Access Compliance Report Public Rights-of-Way (Curb Ramps)

Intersection ID: 10024504 Main Street: CRUMP RD **Cross Street: N/A** Location: Ε ADA ID: BE1D968AC8F0 Ramp Type: BlendTrans1 Initial Pass/Fail: Fail **Overall Compliance: No Severity Score:** 10

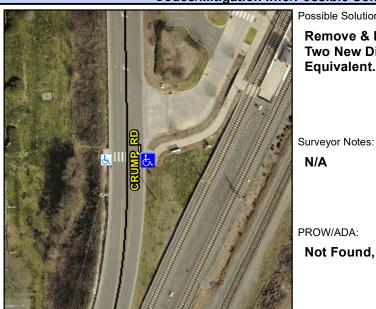
Not Found, R304.5.1, R304.5.3

Field Measurements/Component Compliance					
Compliance Description		Data	Comp	liance Description	Data
N/A	Ramp Length (in)	54.0	Yes	BlendTrans Slope (%)	3.6
No	Ramp Width (in)	47.0	No	BlendTrans XSlope (%)	2.4
N/A	Flare Type LT	N/A	N/A	Flare Type RT	N/A
N/A	Flare Slope LT (%)	N/A	N/A	Flare Slope RT (%)	N/A
N/A	Flare Traversable LT?	N/A	N/A	Flare Traversable RT?	N/A
N/A	Landing Length (in)	N/A	N/A	DWS Provided?	N/A
N/A	Landing Width (in)	N/A	N/A	DWS Contrast?	N/A
N/A	Landing Slope (%)	N/A	N/A	DWS Length (in)	N/A
N/A	Landing X Slope (%)	N/A	N/A	DWS Full Width?	N/A
N/A	Landing Curb? (Y/N)	N/A	N/A	DWS Offset (in)	N/A
N/A	Shared Landing?	N/A			
N/A	Gutter Ponding?	N/A	N/A	Gutter Slope (%)	N/A
N/A	Gutter Lip Ht (in)	N/A	N/A	Gutter X Slope (%)	N/A
N/A	Painted X Walk1?	Yes	N/A	Painted X Walk2?	N/A
	X Walk 1 Direction	To W		X Walk 2 Direction	N/A
	X Walk 1 Width (in)	120.0		X Walk 2 Width (in)	N/A
	X Walk 1 Slope (%)	2.3		X Walk 2 Slope (%)	N/A

X Walk 1 X Slope (%)	0.8		X Walk 2 X Slope (%)	N/A
N/A	Ramp inside XWalk1?	Yes	N/A	Ramp inside XWalk2?	N/A
	Road Slope (%)	0.8		Clear Space?	N/A
	Road X Slope (%)	2.3	N/A	Clear Space to XWalk (in)	N/A
N/A	Any Obstructions?	N/A	N/A	Storm Grate/Utility Hazard?	N/A
	Obstruction Type			Storm Grate/Utility Type	
		N/A			N/A
			Yes	Surface Condition? (G/P)	Good
			No	Curb Slope (%)	20.5

CRUMP RD Street 1 Name Stop Condition-Street 1 None Street 2 Name N/A Stop Condition-Street 2 N/A Possible Solutions: Remove & Replace Curb Ramp With **Two New Directional Ramps or** Equivalent.
